DESIGNED: JM	DRAWN: RP	CHECKED: JAM	<p align="center"><b>GRADING PLAN</b></p> <p align="center">203 KRESSON ROAD BLOCK 218.42 LOT 1.01 VOORHEES TOWNSHIP CAMDEN COUNTY, NEW JERSEY</p> <p align="center"><b>TRISTATE ENGINEERING AND SURVEYING, PC</b></p> <p align="center">P.O. BOX 1304 BLACKWOOD, NJ 08012 OFFICE: (856) 677-8742 FAX: (856) 879-2024 www.tristatecivil.com</p>	
DATE SIGNED:		REVISIONS		
			NO.	DATE
<p><b>JOSEPH A. MANCINI</b></p> <p>New Jersey Professional Engineer Lic. No. 24GE04579300</p>			SCALE:	DATE:
			1"=30'	12/13/19
			PROJECT NO.:	SHEET:
			19-075	1 OF 1

February 5, 2021

**Re: Stofman  
Bulk Variance & Grading Review #1  
Block 218.42 Lot 1.01  
Location: 203 Kresson Road  
Zone: MDR-R75 (Medium Density Residential)  
Our File: HVOZ0218.04**

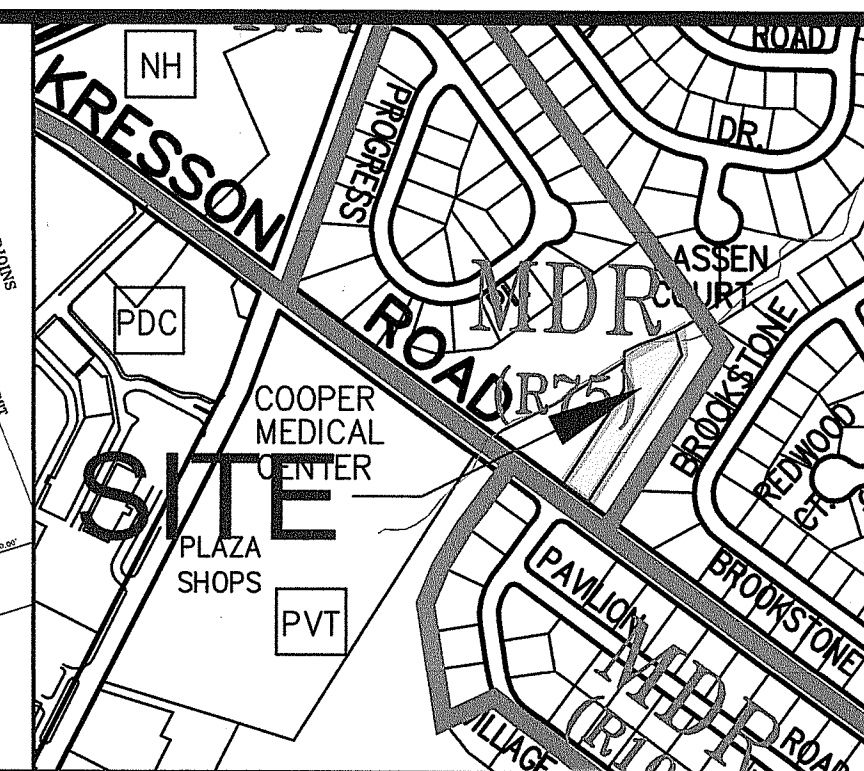
- a. **Section 150.12(B)(1)** – No grading, construction or alteration of a lot or lots shall be permitted within five feet of a side or rear property line; a retaining wall is located along the easterly property line.
- b. **Section 150.12(B)(1)** – No grading, construction or alteration of a lot or lots shall be permitted within five feet of a side or rear property line; pool equipment proposed 1.81 feet from westerly property line.
- c. **Section 150.12(A)** – Accessory structures are not expressly permitted in the subject area; existing treehouse will remain in the rear yard.
- d. **Section 150.13(A)(2)** – Accessory buildings and structures shall not exceed 15 feet in height; existing treehouse exceeds allowable height.

- e. **Section 150.14(B)(1)(a)2** – Fence height shall be no more than four (4) feet when located from the front corners of any building to the side property line and along any side property line to a point parallel with the rear corner of the building. A six (6) foot high fence is proposed in the area to the side of the building between the front and rear building lines.
- f. **Section 150.14(B)(3)(f)1** – Landscaping consisting of evergreen plantings shall be planted in front of all fences five (5) feet and higher that parallel the front property line.

Such plantings shall be a minimum of three (3) feet high, as measured from grade level, at the time of planting, and there shall be a maximum spacing of six (6) feet, center to center, between evergreens. The landscaping required in front of fences shall be installed within thirty (30) days after the fence has been installed. No landscaping is proposed in front of the propose six (6) foot high fence that is parallel to front property line.

- g. **Section 150.13(A)(e)** – The maximum number of sheds permitted is two and the total floor area of all sheds shall not exceed 200 square feet; existing treehouse and proposed shed will exceed total allowable floor area for sheds.

- k. Section 1-3 – The name and address of the applicant clearly stated on the plan.

- l. Section 6-1 – Stream encroachment, flood boundary, and / or wetland lines shall be shown and a source of the information shall be noted on the plan. In case where no study is available, that shall be noted on the plan.
- m. Section 6-2 – Must have bearing and distances with NJDEP permit number and date of approval for encroachment line, or, if not delineated, must have flood boundary elevation based on a State approved or accepted study.
- n. Section 6-3 – All construction and grading activities shall comply with the requirements of applicable NJDEP Regulations. The applicant is responsible for obtaining a jurisdictional determination from the appropriate authorities.
- o. Section 7-2 – Proposed drainage patterns shall be denoted with flow arrows. Spot elevations shall be provided along major drainage paths.

The Applicant should revise the plans to identify wetlands, wetlands buffers, flood hazard areas, riparian zones, and all other environmentally sensitive areas.
